AGENDA

April 27, 2023

1. **Pledge of Allegiance**
2. **Review of Agenda**
3. **Advertised Public Hearing**
 - A. **PETITION NO. DR-PL20220000558 – Viage Bayshore Marina – A request for approval of a site plan with deviations pursuant to LDC Section 10.02.03.F and seeks four deviations: (1) from LDC Section 4.02.16.C.7.c to instead allow an enhanced Type ‘D’ landscape buffer and a solid 8 foot vinyl fence along Riverview Drive to screen the boats and boat racks; (2) from LDC Section 4.02.16.C.10.d to increase the maximum height of 17 feet for stored or displayed boats to 29 feet; (3) from LDC Section 4.02.16.C.10.e to reduce the required 50 foot setbacks to a 15 foot setback from Riverview Drive and a 10 foot setback from Lakeview Drive; and (4) from LDC Section 4.02.16.C.10.g to instead allow an enhanced 10 foot Type ‘D’ buffer with an 8 foot solid vinyl fence along Lakeview Drive, Riverview Drive, and Bayshore Drive, with each street buffer consisting of specific planting and vegetation requirements, for the redevelopment of Viage Bayshore Marina, consisting of ±1.48-acres and located at 3470 Bayshore Drive, Naples, FL 34112, also known as Lots 25, 26, 27, and 28, Block 4, and L

SITE PLAN -
DEVIATIONS

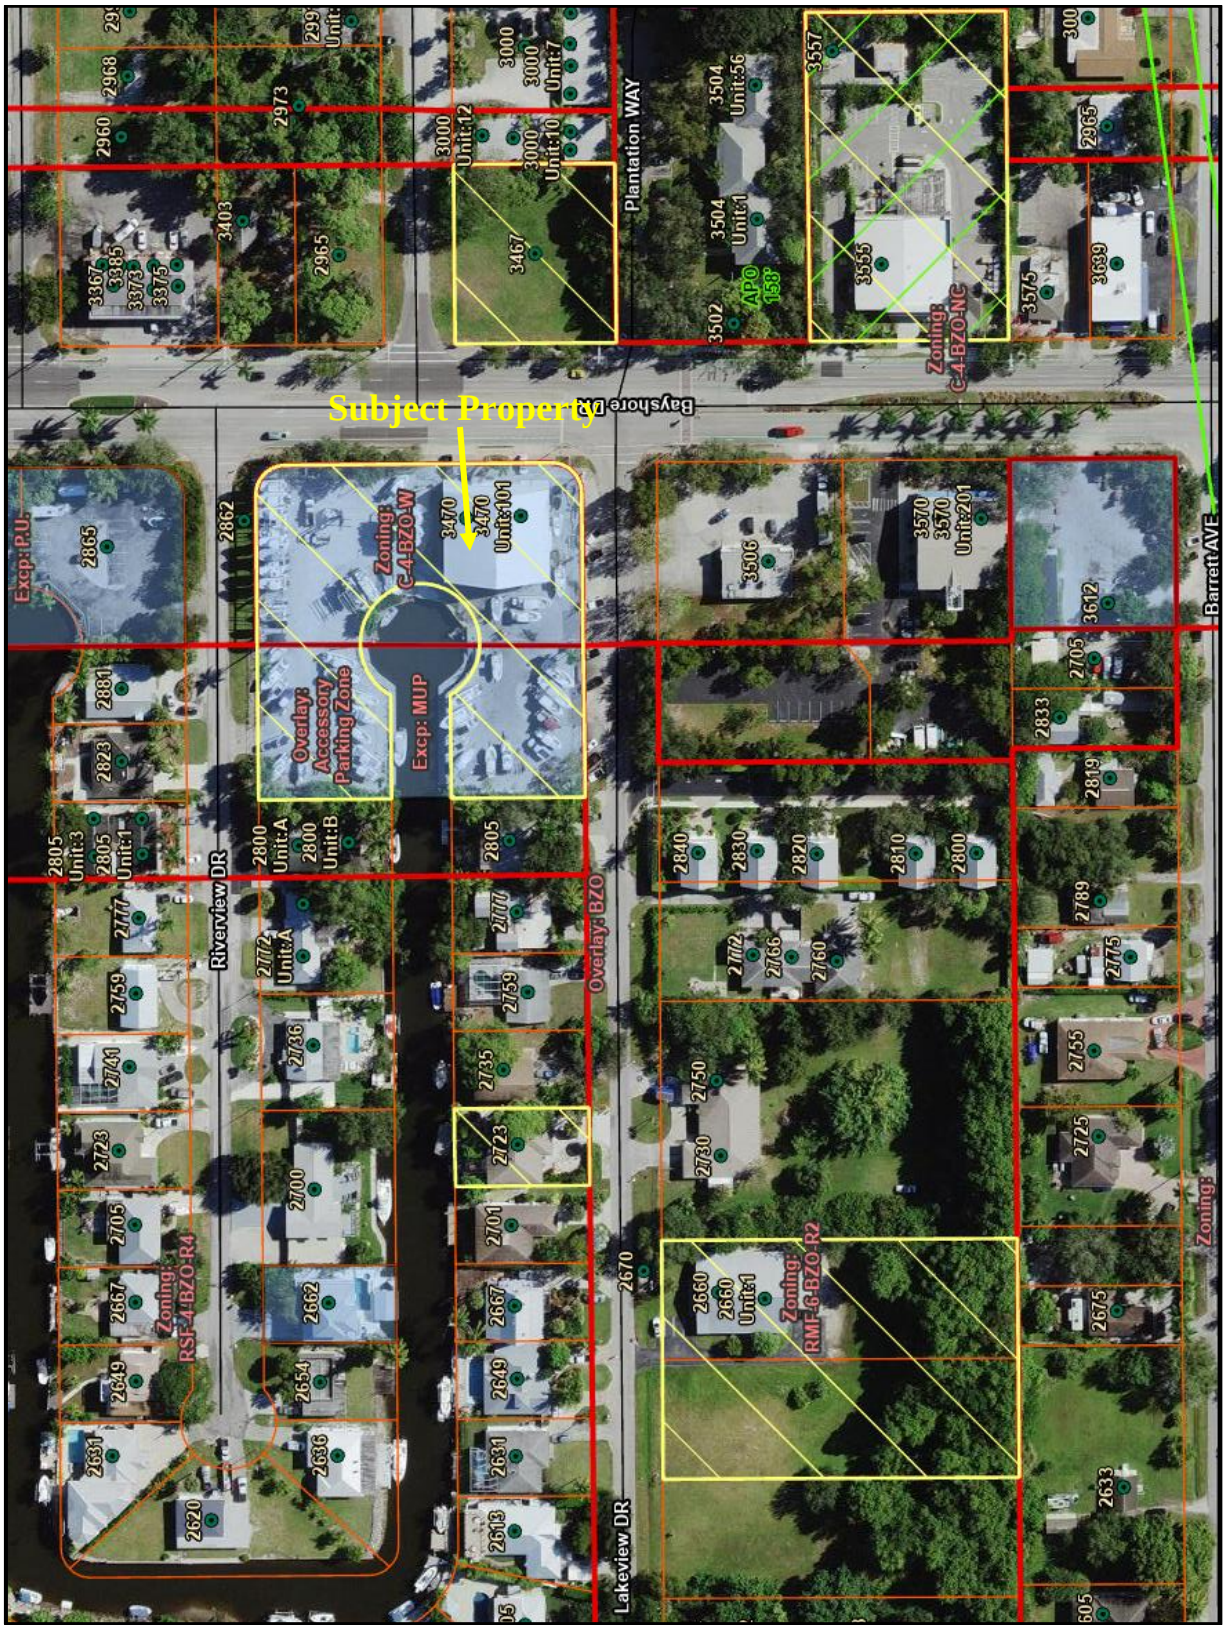
Proposed Deviation #1 seeks relief from LDC Section 4.02.16. C.7.c “Marinas and Boatyards,” which requires all boat racks to be enclosed with a wall or fence, with boats not exceeding the height of the enclosure, to instead allow an enhanced Type ‘D’ landscape buffer and a solid 8’ vinyl fence along Riverview Drive to screen the boats and boat racks. The enhanced 10’ Type ‘D’ buffer shall consist of a row of Cabbage Palms 16’-24’ in height (clear trunk) at the time of planting, a row of Dahoon Hollies a minimum of 6’ in height at the time of planting, a row of Green Buttonwoods a minimum 10’ in height at time of planting and spaced a maximum 30’ on center, and a hedge that is a minimum 36” in height at time of planting and spaced 36” on center.

Proposed Deviation #4 seeks relief from LDC Section 4.02.16. C.10.g “Buffering Standards - Outdoor Storage, Display or Sales Areas,” which requires a 10’ Type ‘B’ buffer for outdoor storage areas to instead allow an Enhanced 10’ Type ‘D’ buffer along Lakeview Drive consisting of a solid 8’ vinyl fence, a hedge that is a minimum of 36” in height at time of planting and spaced 36” on center, a row of Cabbage Palms 16’-24’ in height (clear trunk) at time of planting, and Silver Buttonwoods 14’ in height at time of planting and planted 10’ on center.

Proposed Deviation #5 seeks relief from LDC Section 4.02.16. C.10.g “Buffering Standards- Outdoor Storage, Display or Sales Areas,” which requires a 10’ buffer consisting of trees a minimum of 14’ in height spaced 30’ on center and a double hedge row 3’ in height and spaced 3’ on center for outdoor display or sales areas, to instead allow an enhanced 10’ Type ‘D’ buffer along Riverview Drive consisting of a solid 8’ vinyl fence, a row of clustered Cabbage Palms 16’-24’ in height (clear trunk) at time of planting, a row of Dahoon Hollies a minimum of 6’ in height at time of planting, a row of Green Buttonwoods a minimum 10’ in height at the time of planting and spaced a maximum 30’ on center, and a hedge that is a minimum 36” in height at the time of planting and spaced 36” on center.

Proposed Deviation #6 seeks relief from LDC Section 4.02.16. C.10.g “Buffering Standards - Outdoor Storage, Display or Sales Areas,” which requires a 10’ buffer consisting of trees a minimum of 14’ in height spaced 30’ on center and a double hedge row 3’ in height and spaced 3’ on center for outdoor display or sales areas, to instead allow a 10’ landscape buffer along Bayshore Drive consisting of a solid 8’ vinyl fence and a hedge that is a minimum of 36” in height at the time of planting and spaced 36” on center, and a row of Cabbage Palms 16’-24’ in height (clear trunk) at the time of planting and a row of Silver Buttonwoods 14’ in height at the time of planting to satisfy vegetation requirements.

Staff Analysis and Recommendation: Staff sees no detrimental impact to the surrounding area should the deviation be approved. Landscaping staff has reviewed and evaluated the proposed deviation from the site plan and found no issue with consistency. This deviation is site-specific as represented on the Site Plan. Therefore, Zoning Staff recommends **APPROVAL** of this deviation.

Staff Analysis and Recommendation: Staff sees no detrimental impact to the surrounding area should the deviation be approved. Landscaping staff has reviewed and evaluated the proposed deviation from the site plan and found no issue with consistency. This deviation is site-specific as represented on the Site Plan. Therefore, Zoning Staff recommends **APPROVAL** of this deviation.

Staff Analysis and Recommendation: Staff sees no detrimental impact to the surrounding area should the deviation be approved. Landscaping staff has reviewed and evaluated the proposed deviation from the site plan and found no issue with consistency. This deviation is site-specific as represented on the Site Plan. Therefore, Zoning Staff recommends **APPROVAL** of this deviation.

Staff Analysis and Recommendation: Staff sees no detrimental impact to the surrounding area should the deviation be approved. Landscaping staff has reviewed and evaluated the proposed deviation from the site plan and found no issue with consistency. This deviation is site-specific as represented on the Site Plan. Therefore, Zoning Staff recommends **APPROVAL** of this deviation.
